Warren County Regional Planning Commission

Subject: RPC Recommendation for Daniel Kahmann PUD Stage 1 Rezoning

MEETING DATE: July 23, 2026
TO: WCRPC Executive Committee
FROM: Tara Allen, Planner I
SUBJECT: Daniel Kahmann PUD Stage 1 Rezoning

Aerial of the subject site with topography shown.

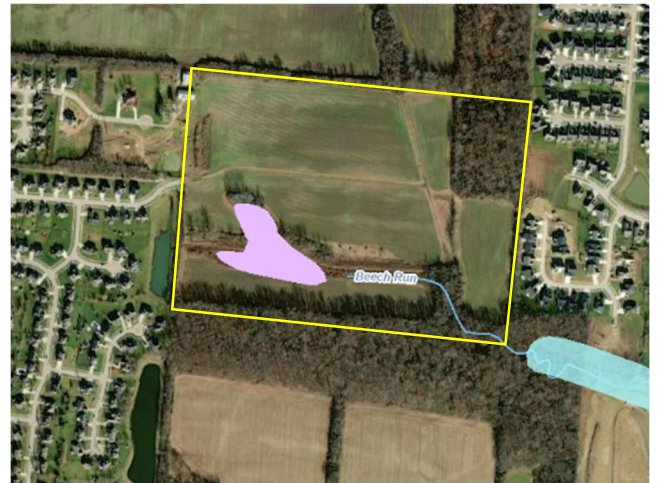
ENVIRONMENTAL FEATURES: The site is largely flat, but there are some gentle slopes near the southeastern corner. The majority of the site is open field, but there are wooded areas in the northeastern corner as well as on the southern portion of the property. The OKI Environmental Mapper indicates that there is a large wetland in the wooded area on the southern portion of the property. The existence of this wetland should be field-verified, and if it is present, efforts should be made to preserve it. The OKI Environmental Mapper also indicates that there is a stream (Beech Run) on the southeastern portion of the property. The Concept Plan illustrates that there will be open space areas near the wetland and stream locations, which should help to preserve these natural features. However, the stream does appear to run through the rear yards of Lots 132, 133, 99, 100, and 101. No portion of the property appears to be within a flood hazard area.

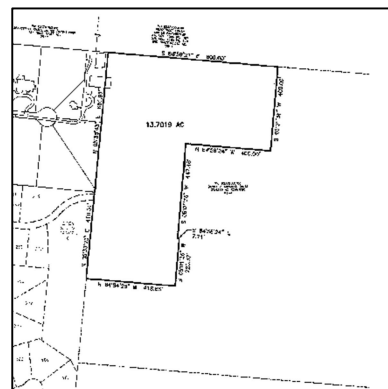
STORMWATER MANAGEMENT: The Concept Plan illustrates four (4) ponds within the open space areas on the site, and the project narrative indicates that the open space areas will serve stormwater management functions in addition to their aesthetic purposes. The Concept Plan notes also state the following in regard to stormwater management:

"The existing offsite stormwater management basin 1 will be eliminated in favor of a larger regional basin in the 70.9292 acre tract."

This note refers to the existing stormwater management basin in the adjacent subdivision of the Estates at Crown Point. The Preliminary Plan Approval for the Estates at Crown Point (December 21st, 2017) allows for an off-site stormwater management facility. Current Subdivision Regulations require stormwater management facilities to be on a separate open space lot within the subdivision. A Revised Preliminary Plan for the Estates at Crown Point would be subject to the current Warren County Subdivision Regulations and thus would not be permitted to have off-site stormwater management facilities.
